COMMITTEE REPORT ON

WESTERN MILITARY FORTS

November 1965

REPORT OF COMMITTEE TO REVIEW WESTERN FORTS'
INTERPRETIVE DEVELOPMENT PROGRAMS

PROPOSED VISITOR CENTER
FOR BENT'S FORT

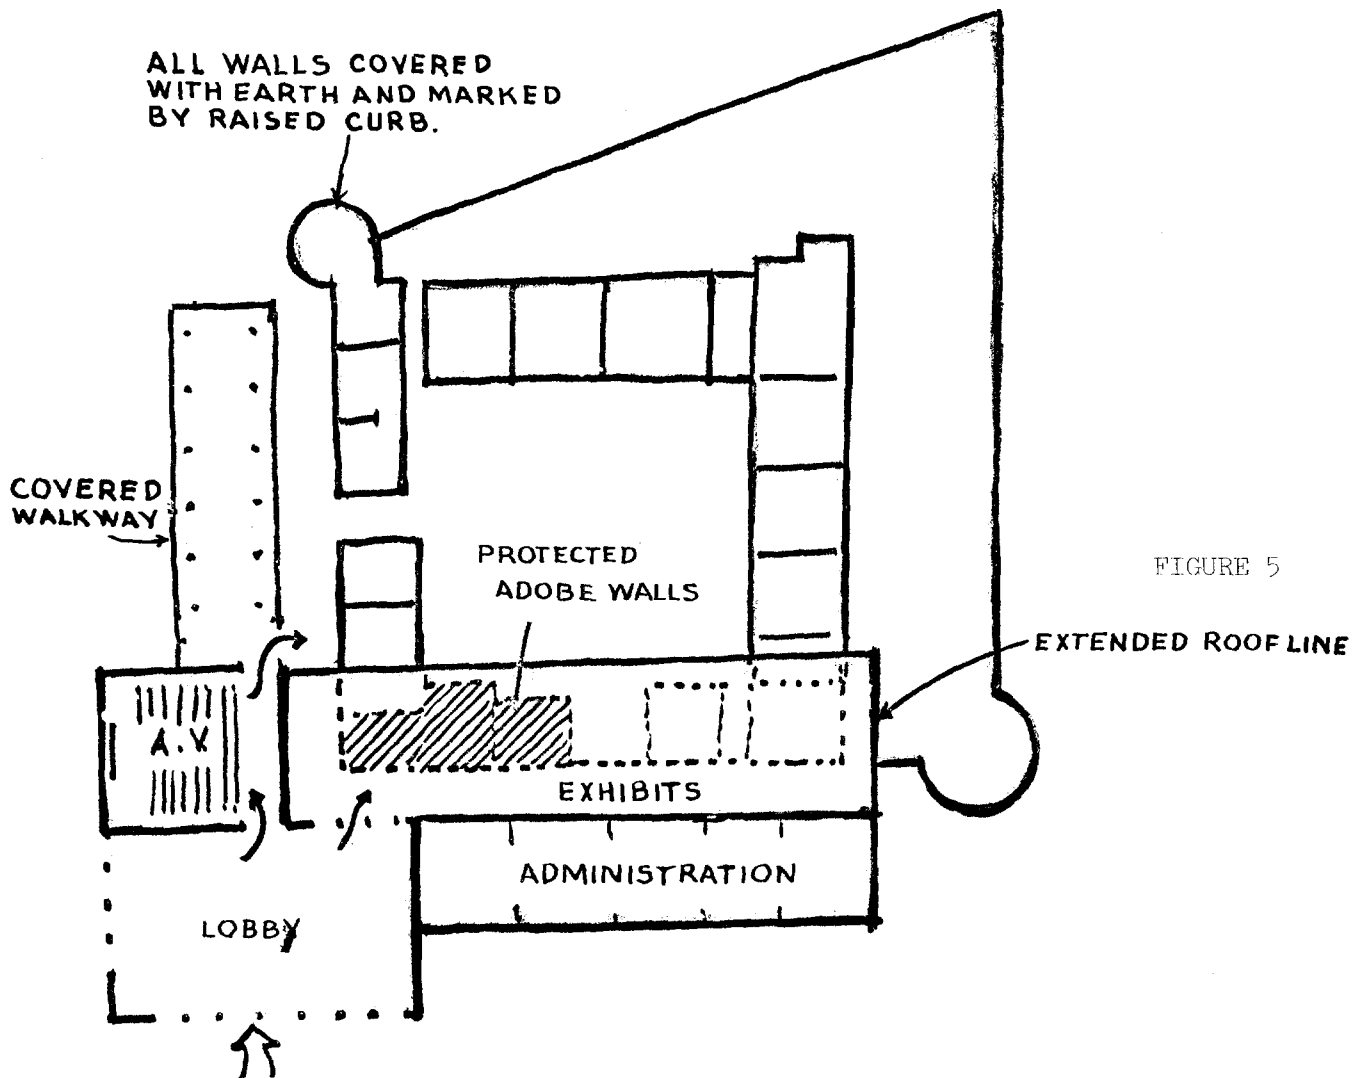
Alternative C--our choice has the disadvantage of dashing the expectations of the local populace, who have been led to believe the fort will be reconstructed, and it may be that political pressures would make this choice untenable. However, it has such strong arguments for it that we think it must be proposed. First you preserve the site and its remains, second you can build a visitor center not only adjacent to the site but by a little architectural maneuvering, actually protect a certain part of the wall that does remain. You have a place planned for human traffic and background briefing. You have the stabilized remains at hand immediately after having had the role of the fort interpreted. You have one building to erect--and that one will do its job.

Attached are three sketches of possible architectural arrangements which would help shelter the site as well as make it immediately available.

COMMITTEE SUGGESTION FOR
FORT BOWIE ENTRANCE ROAD
VISITOR CENTER, RESIDENTIAL
AND MAINTENANCE AREAS.

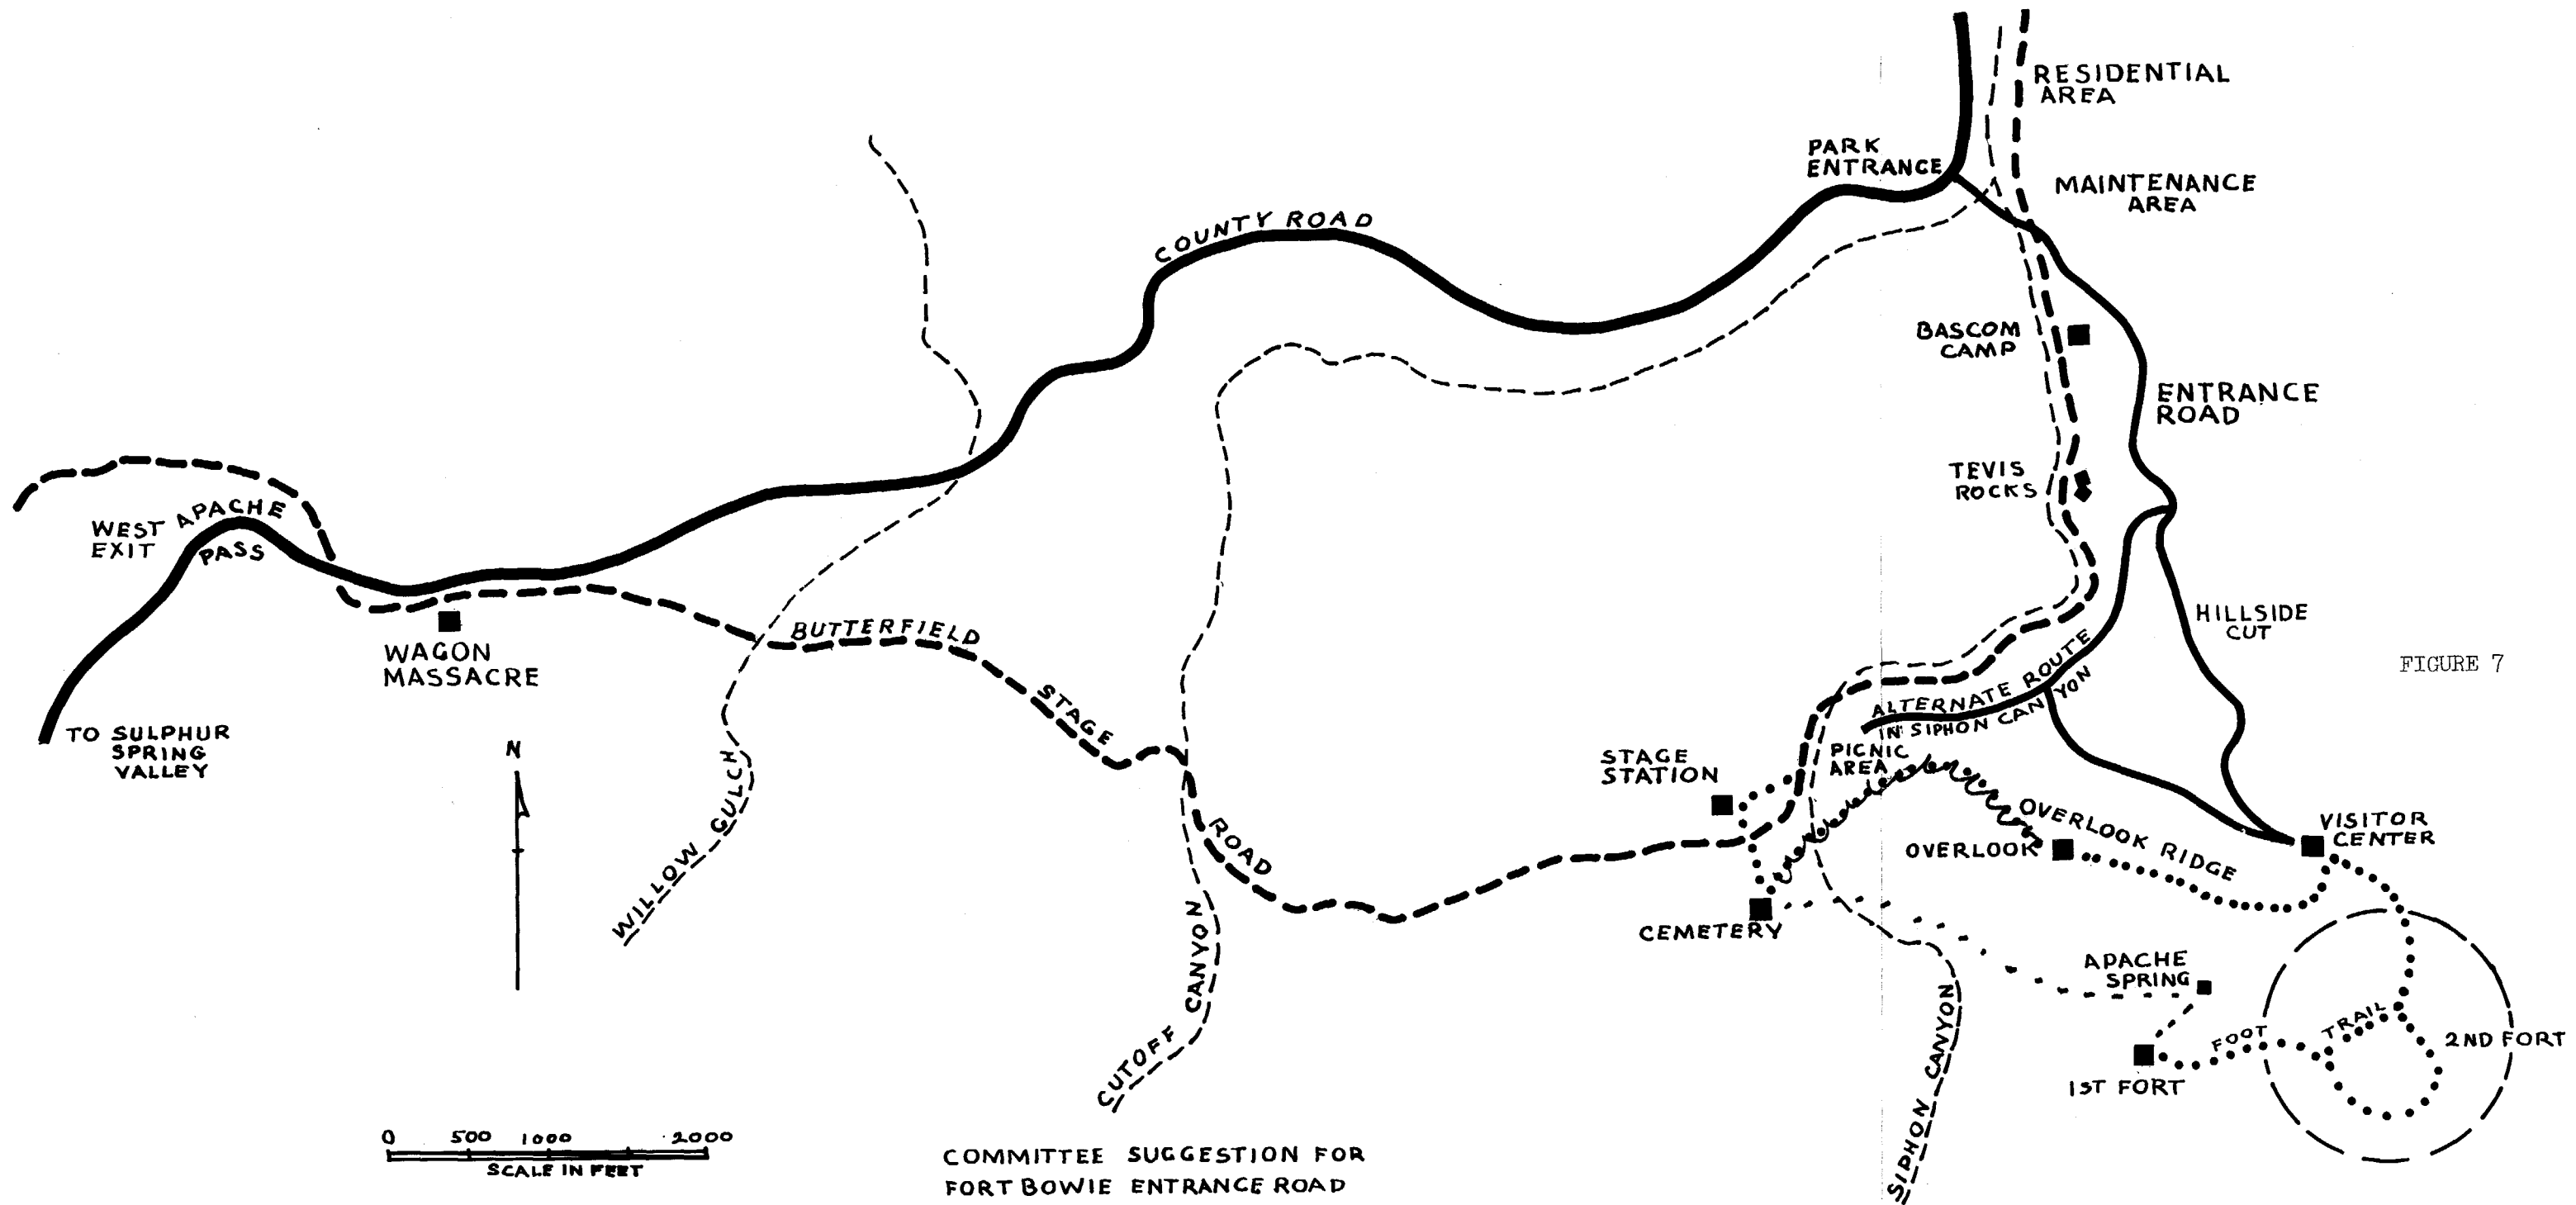
Location intrusive on historic scene where indicated on Master Plan Brief. Suggests they be placed at mouth of Siphon Canyon and related to take-off point of park entrance road from county road, if entrance road recommendation made above is adopted. If entrance road recommendation not accepted, then locate residences near present county road and park road junction.
